STAFF RECOMMENDATION 1218 6th Avenue North February 17, 2016

Application: Partial demolition; Alterations; New construction—addition
District: Germantown Historic Preservation Zoning Overlay
Council District: 19
Map and Parcel Number: 08209027500
Applicant: Brad Northcut
Project Lead: Melissa Baldock, melissa.baldock@nashville.gov

Description of Project: Application is re-construct and enclose a two-story side porch, construct a rear addition that is wider than the historic house, and install storm windows.

Figures 2 & 3 show the existing two-story side porch.

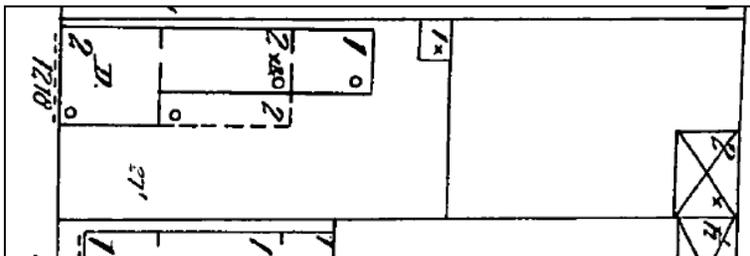
Partial Demolition & Porch Enclosure. The applicant proposes to remove the existing materials on the two-story side porch, and enclose it (Figures 2 & 3). The date of construction of the two-story side porch is not known, but it appears in the 1897 Sanborn Map (Figure 4). Although a two-story porch does appear on early maps, the existing materials of the porch are likely not original, and are in disrepair. Staff finds that changing the materials on the side porch, while maintaining the porch's existing form, is appropriate given the condition of the porch.

The applicant is also proposing to re-configure the enclosure on the ground floor of the side porch and enclose the second story. The design guidelines state that "Enclosing side porches may be appropriate where the visual openness and character of the porch are maintained." The new enclosure design mimics the existing enclosure, and staff therefore finds it to be appropriate.

Staff finds that the porch reconstruction meets Section 7.2.2. for appropriate demolition and does not meet Section 7.2.1. for inappropriate demolition. Staff also finds that enclosing the second story of the side porch meets Section 1.6.4. of the design guidelines.

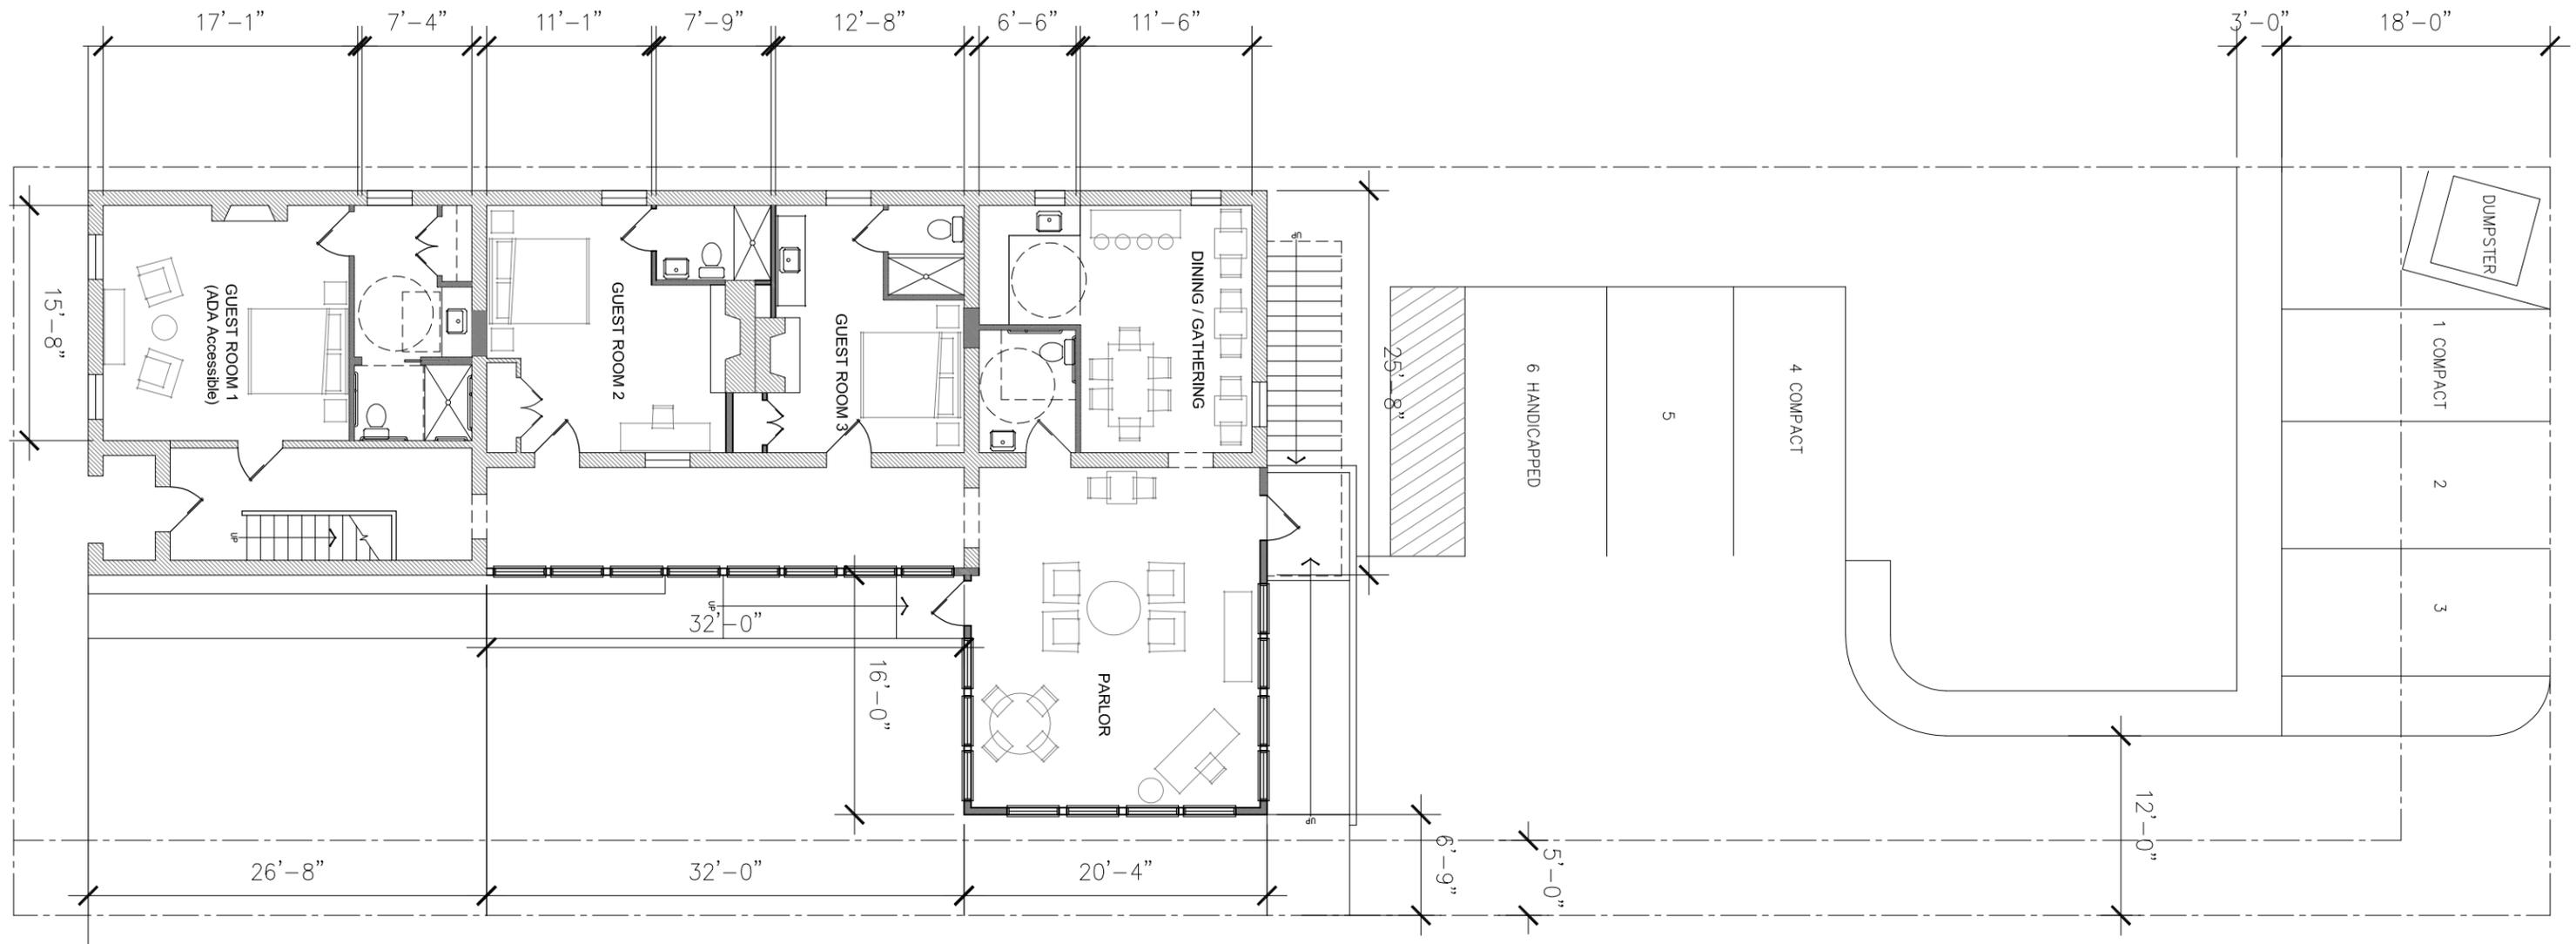
The reconstructed two-story porch will have a window pattern that mimics the existing window pattern on the ground floor of the porch. The one-story addition will also continue with this window pattern. The new windows will be wood or aluminum clad. Staff finds that the proposed windows and doors meet Sections 1.5, 2.5, 2.6, and 4.0. of the design guidelines.
